South Texas Project Electric Generating Station P.O. Box 289 Wadsworth, Texas 77483

November 20, 2008
U7-C-STP-NRC-080065

South Texas Project
Units 3 and 4
Docket Nos. 52-012 and 52-013
Response to Requests for Additional Information and Response Date Extensions

Figure 1

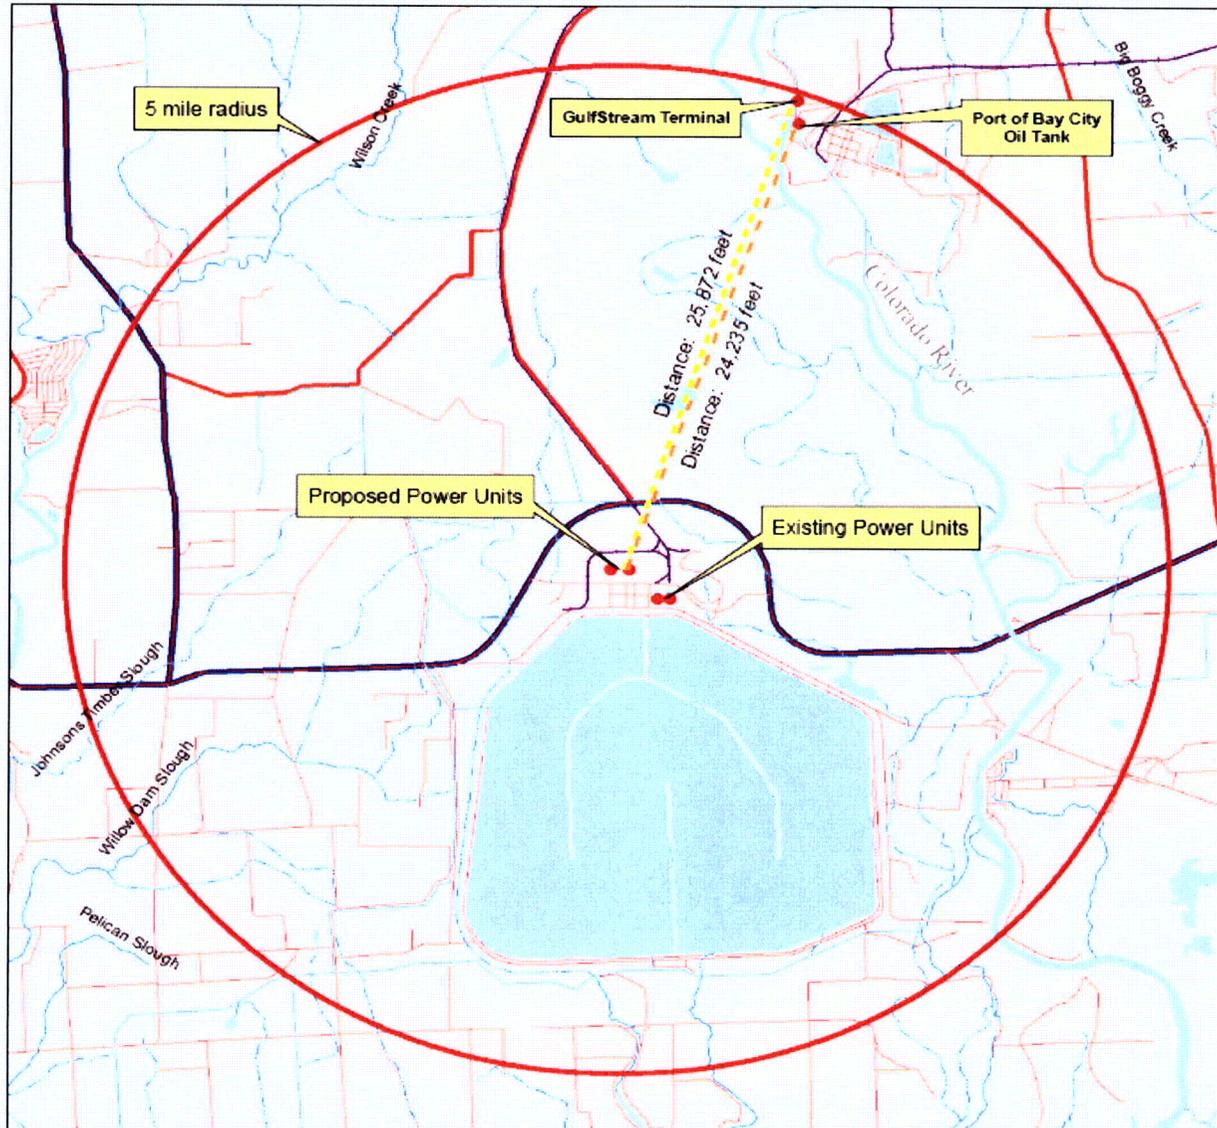
Provide information for which chemicals and parameters were used in the ALOHA model and the DEGADIS model. Please also provide inputs, assumptions, methodology and details used in the TOXDISP (Toxic Dispersion model, Revision 3) modeling.

The first scenario involves the release of the entire contents of a gasoline barge into the Colorado River whereby the formed pool begins to evaporate, travel and disperse as a vapor cloud. The vapor cloud concentrations are evaluated downwind up to the location of the control room intake to ensure that concentrations do not exceed 300 ppm. Similar to the DEGADIS evaluation of the gasoline barge, a virtual point source is assumed.

Downwind Distance	39,241.8 ft (11,960.92 m)	$\sigma_{y0} = s/4.3 = (3000/4.3) = 697.674$ ft This correlates to a downwind distance of 7,000 m. Therefore, L = (4,960.92m) + (7,000m) = 11,960.92m (see Note 1 and Figure 1)
Control Room Intake Height	6.0 m	(Reference 18)
Quantity Spilled	4,604,272.081 kg	The barge transports in quantities of up to 40,000 BBLs or 1,680,000 gallons (6,359.5m ³). (Reference 5). Based upon the liquid density defined below (0.724 g/cm ³), the quantity spilled is calculated.
Air and Water Temperature	84.1°F = 28.9°C = 302.1 K	To maximize evaporation rate, the July mean temperature is used. (Reference 6) Assuming the water temperature to be the same as the air temperature is conservative as the temperature of the Colorado River is consistently cooler than the air or ground temperature. (Reference 7)
Water Vapor Pressure	27.7 mmHg @ 28.9°C = 36.93 mb @ 28.9°C	(Reference 9)

1. The puddle area that would form from the spilled gasoline would take the form of the river. However, many models such as TOXDISP assume the mass from a single point source. Since the spill area is a long rectangle that is perpendicular to the proposed Units, a point source model would not be accurate. In order to account for the large spill and consequently the resulting large vapor cloud at the spill site, a virtual point source is assumed upwind of the real spill. The virtual point source forms a virtual vapor cloud that would be equivalent to the actual vapor cloud after it travels and reaches the spill site. This equivalent virtual source is assumed using the Gaussian distribution. The virtual distance is the distance between the virtual upwind "point source" and the rectangular spill.

This virtual distance represents the generation of a vapor cloud from a point origin that would be of an equivalent cloud size when it reaches the "real" distance at the river. (See Figure 1 below.)
